UNITED STATES PATENT AND TRADEMARK OFFICE

| APPLICATION NO. | FILING DATE | FIRST NAMED INVENTOR | ATTORNEY DOCKET NO. | CONFIRMATION NO. |
|-----------------|-------------|-------------------------|---------------------|------------------|
| 10/023,341 | 12/17/2001 | Charles Richard Elliott | K315.118.101 | 7999 |

Office Action Summary

Paper No:4
Serial Number: 10/023341
Filing Date: December 17,2001

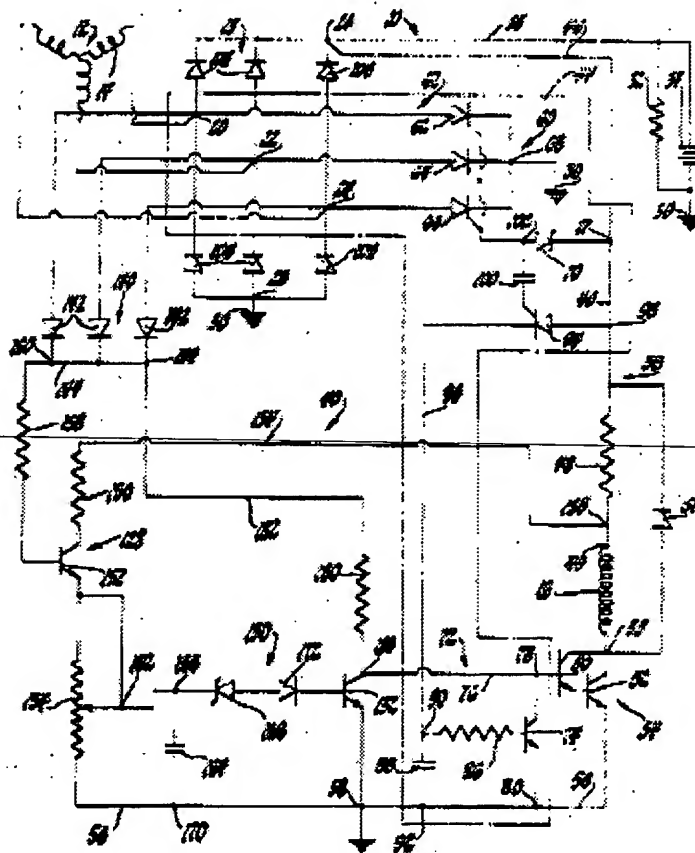
Kirk teaches in figure 1, an over-voltage protection circuit.

A voltage transient is detected by zener 70. Upon detection, circuit 42 connects rectifiers 62,64,66 across the supply 26,28. Normal operation resumes upon the voltage falling below the threshold detected by zener 70. A time delay 86,88 allows the reactive current to decay (sustained transient).
